DATE: November 15, 2019

PROJECT: RFQ CCC-059 Cafeteria and Music Building HVAC and Fire Alarm

SUBJECT: ADDENDUM #1

M1.1

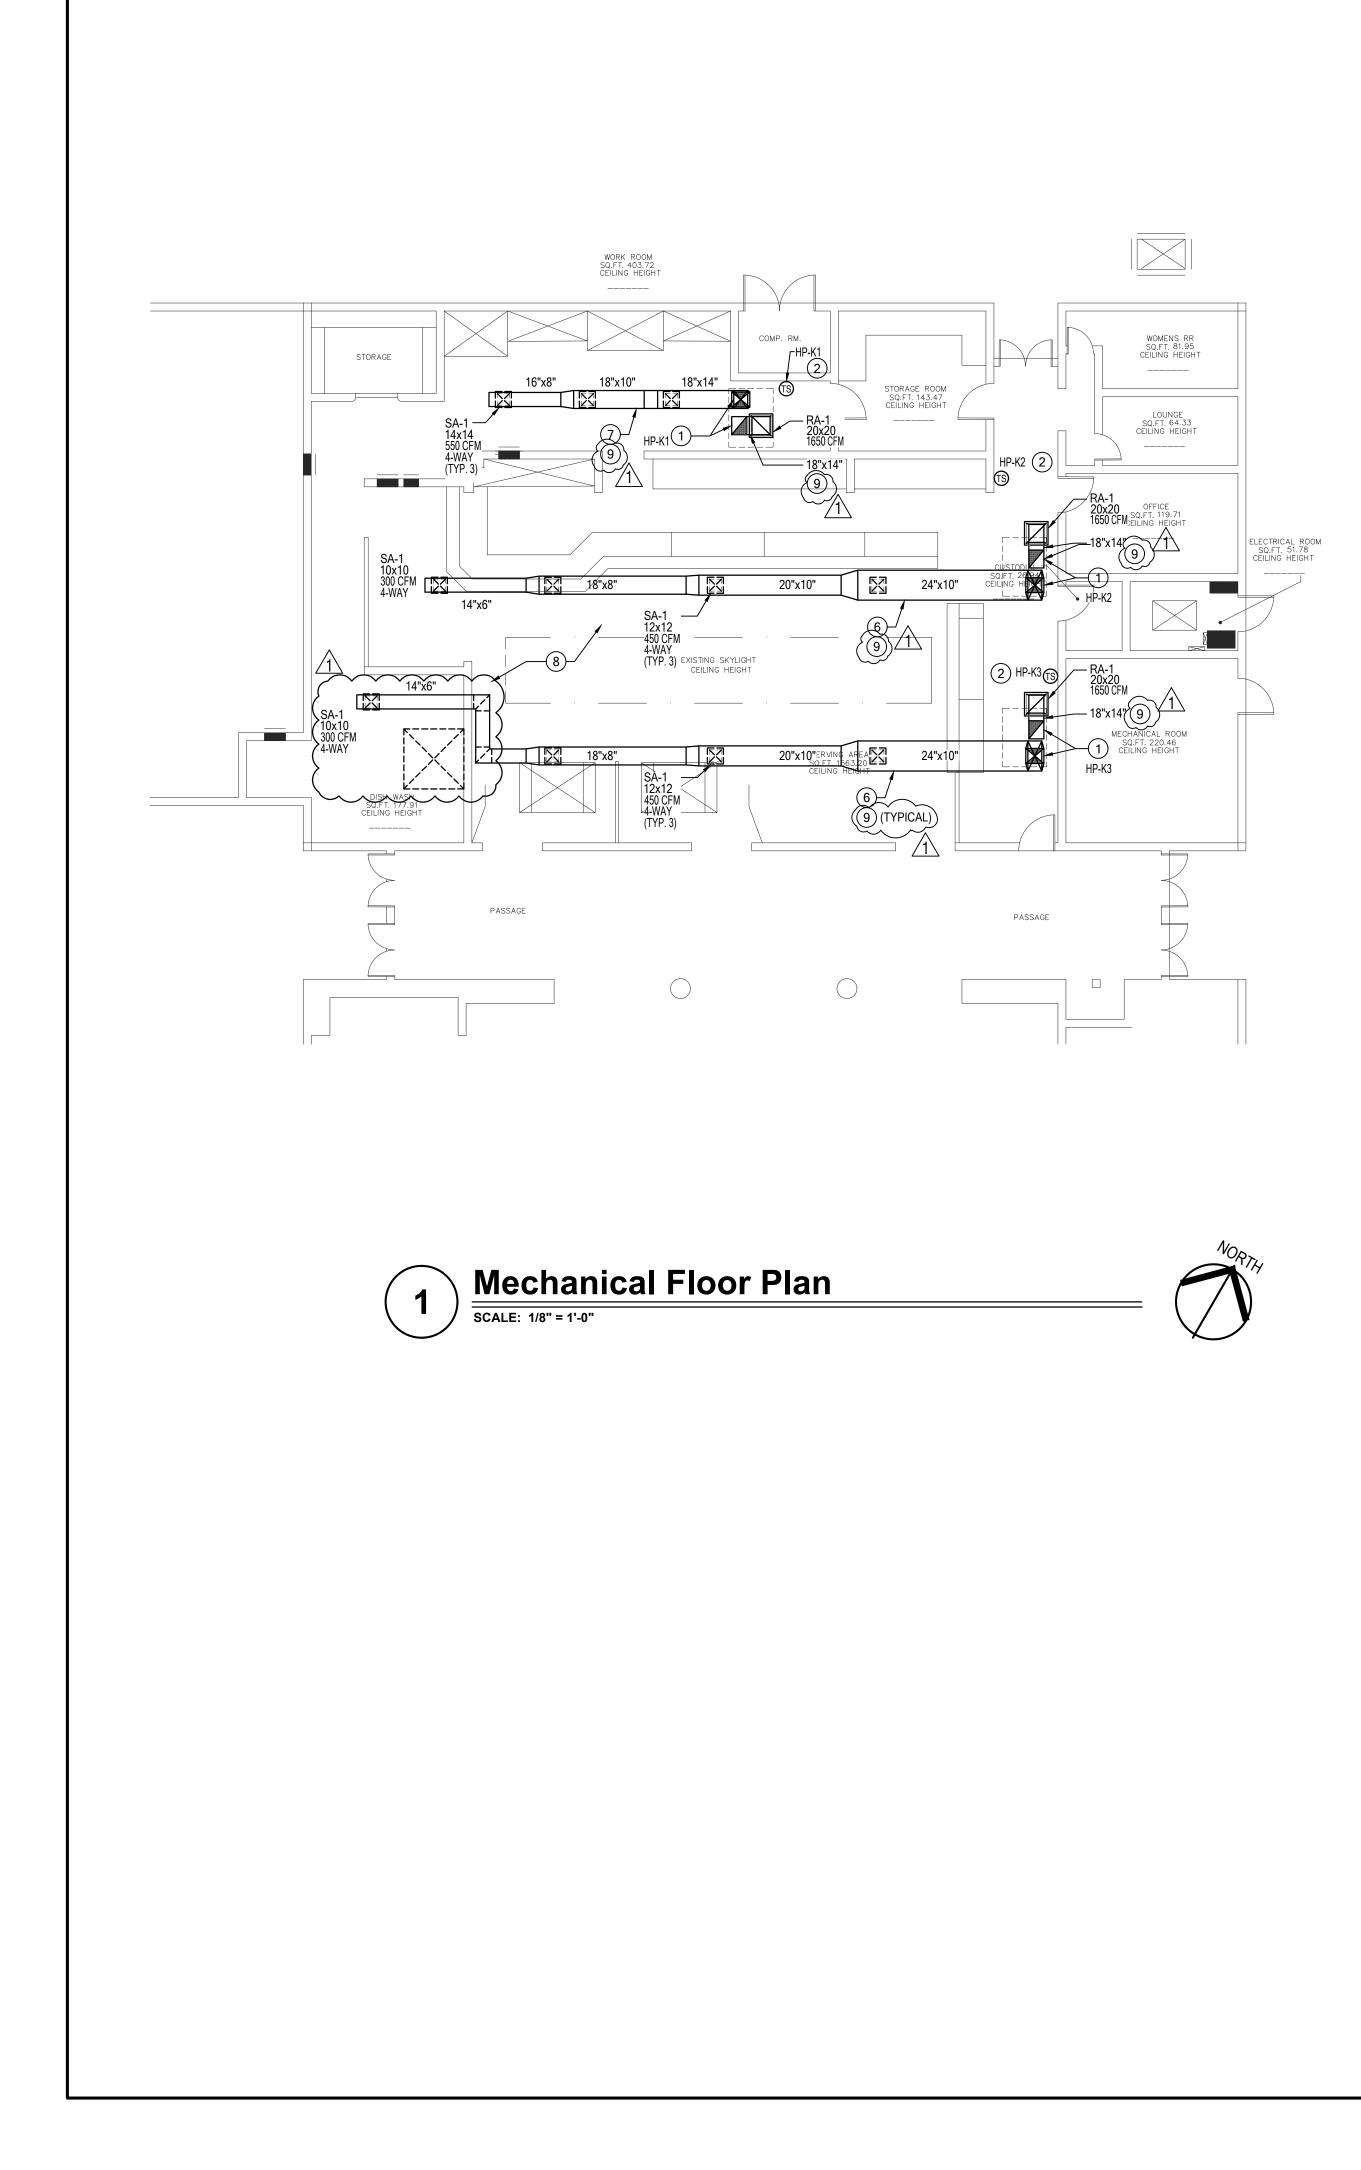
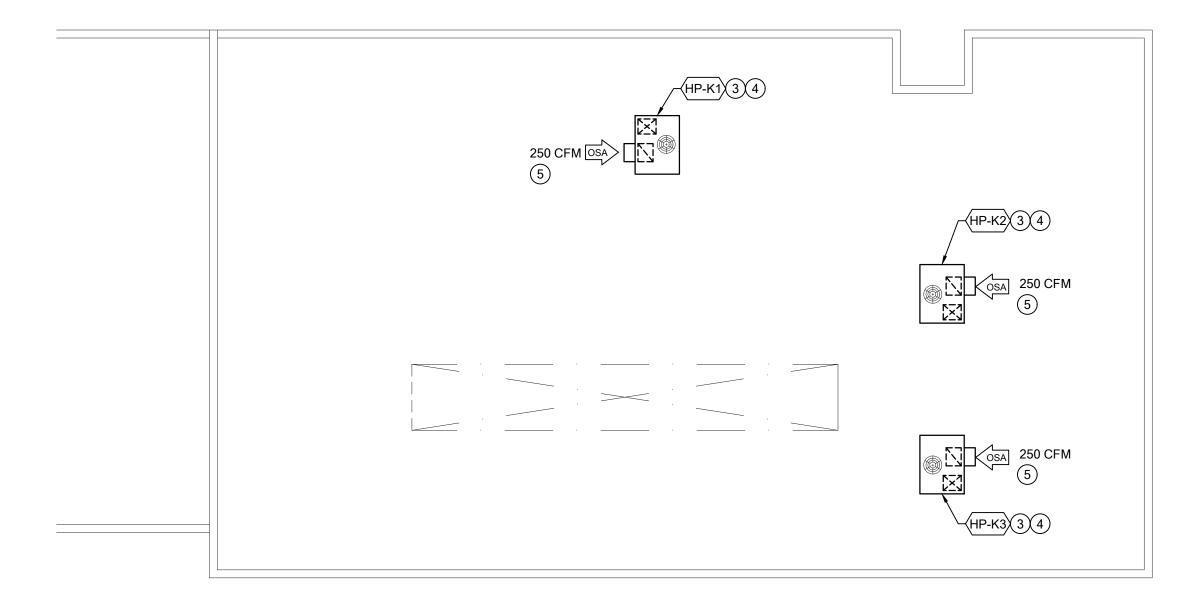
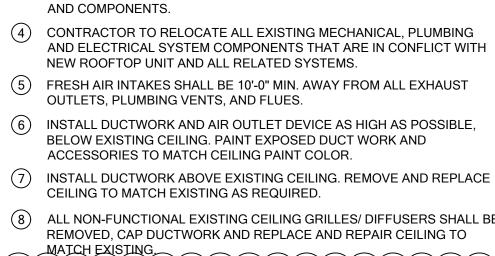
Revisions to Cafeteria Drawing M1.1:

- A. Revise ductwork at dish wash area.
- B. Revise Detail 1 "Mechanical Floor Plan" to add Keynote #9.
- C. Add Keynote #9 to "Plan Key Notes"

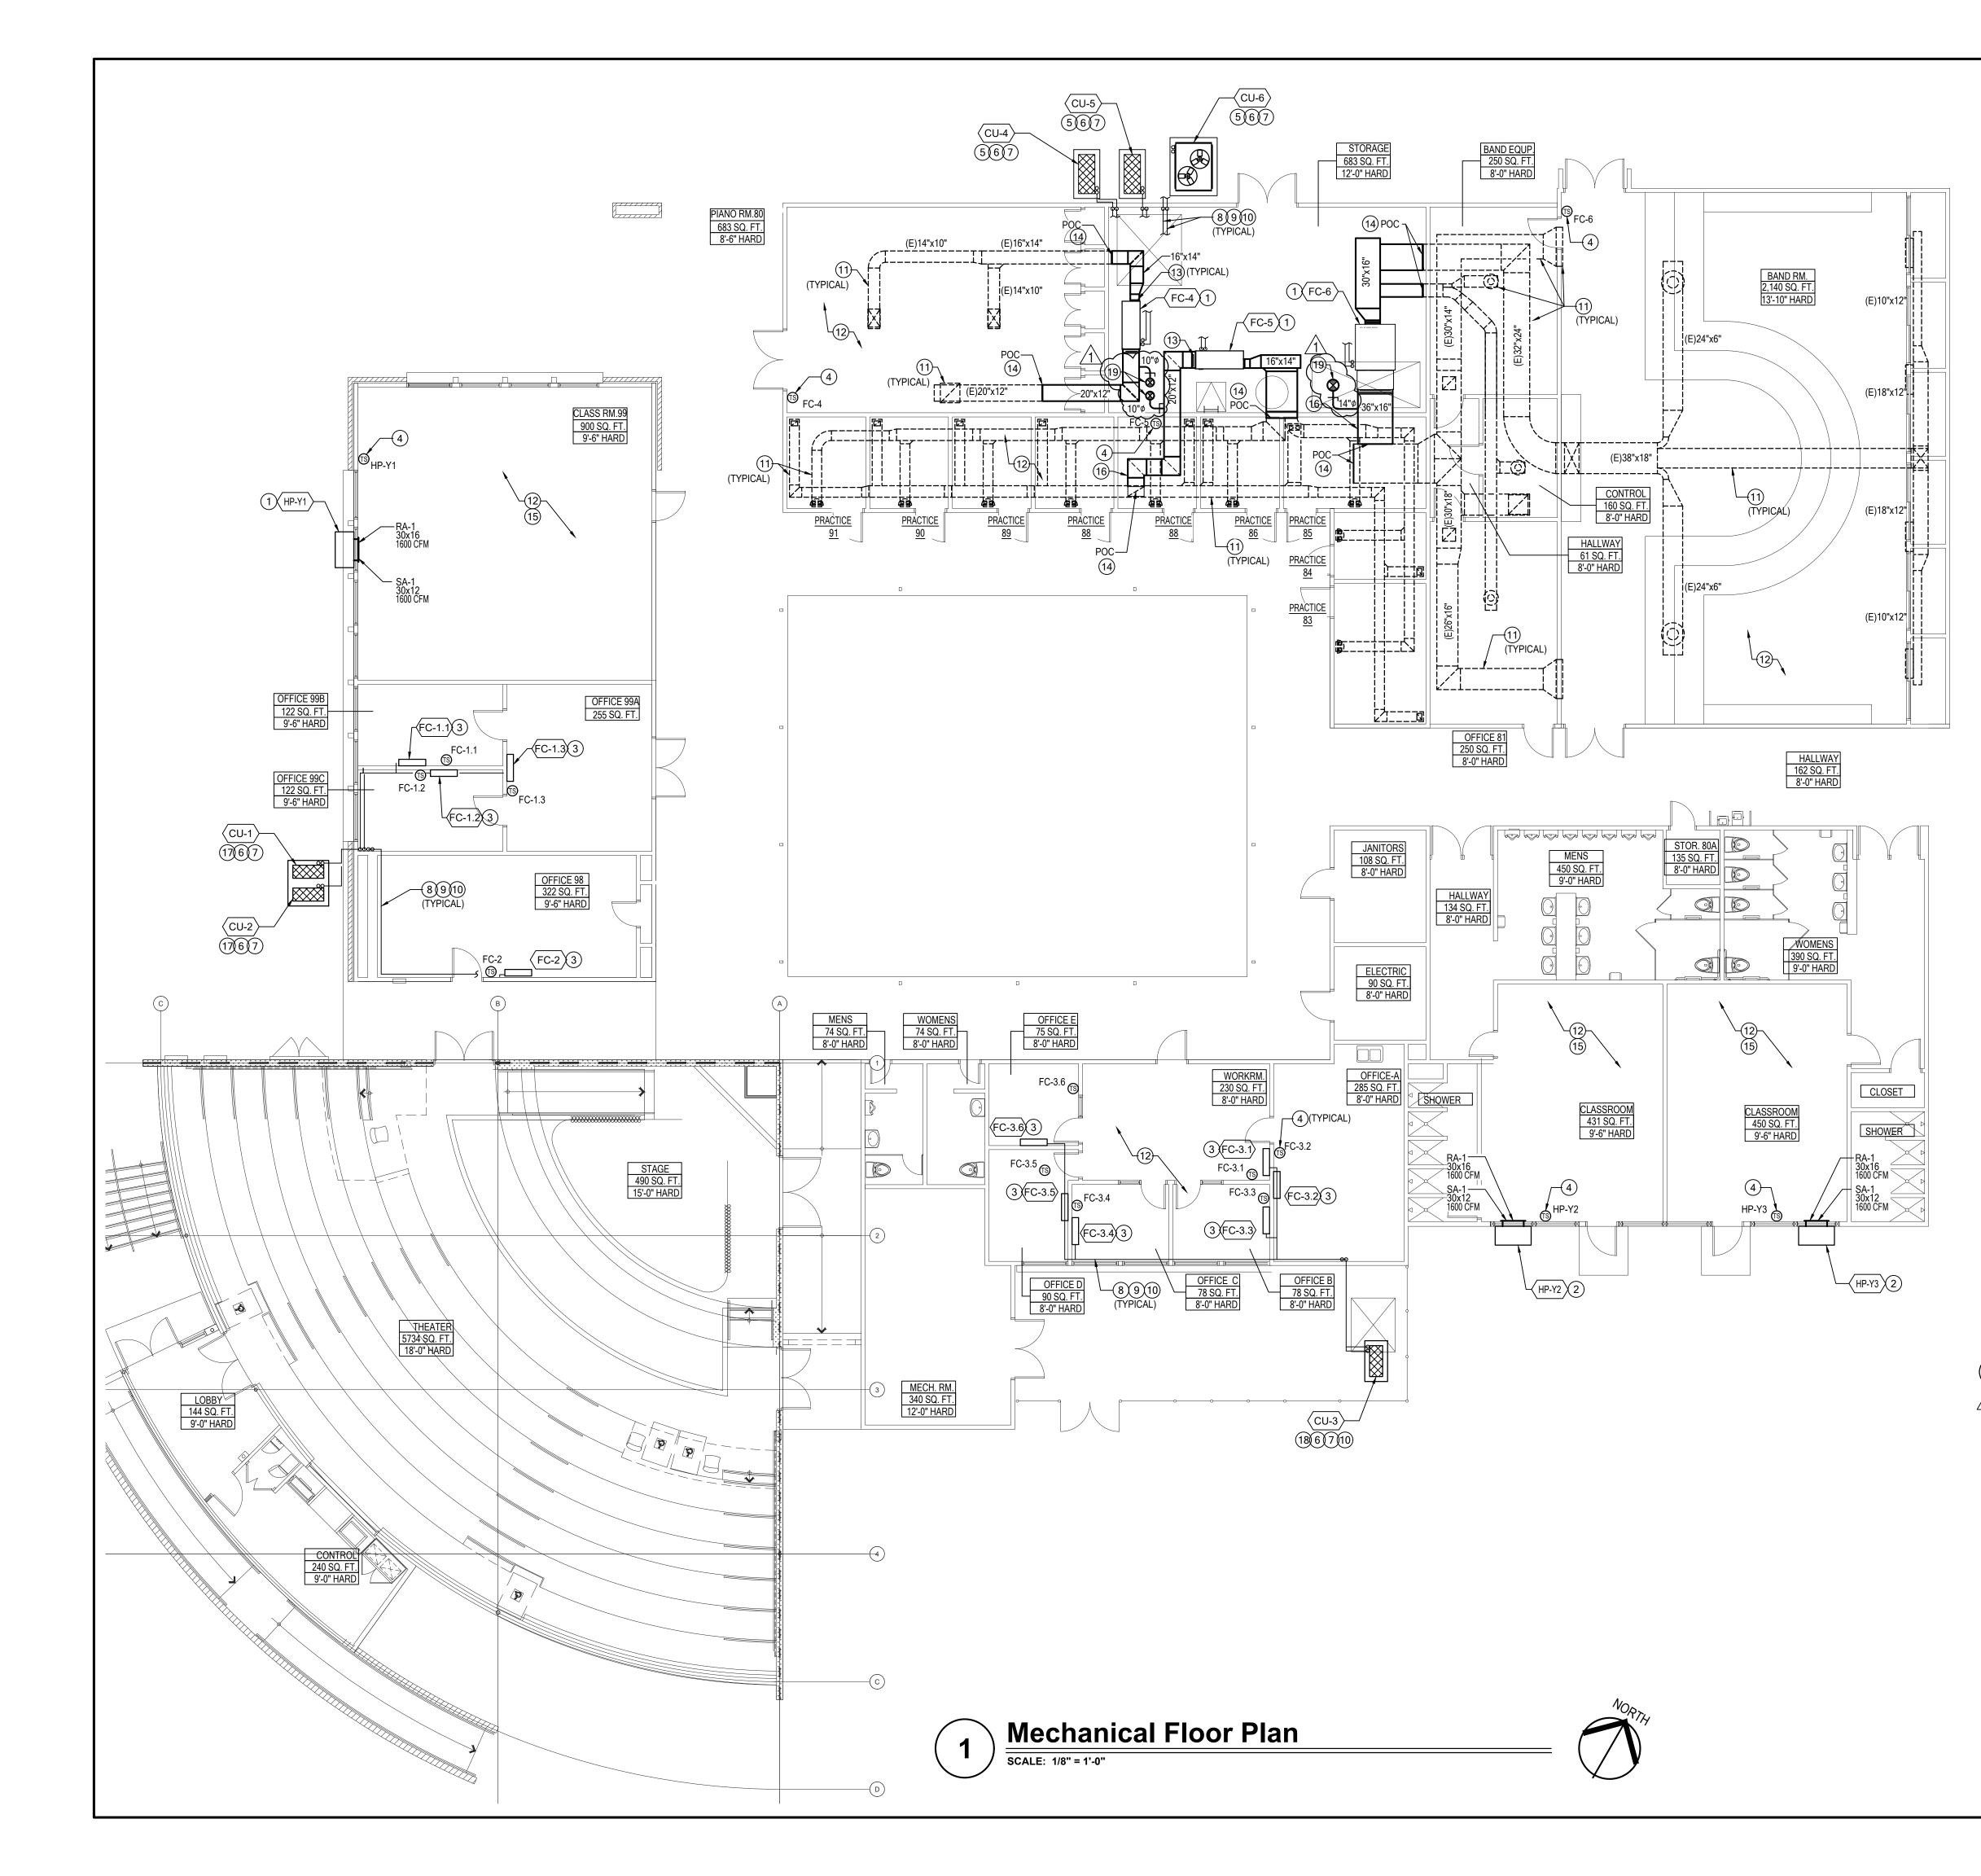
Revisions to Music Building Drawing M1.1:

A. Revise Detail 1 – "Mechanical Floor Plan" to add ductwork with Keynote #19

B. Add Keynote #19 to "Plan Key Notes"
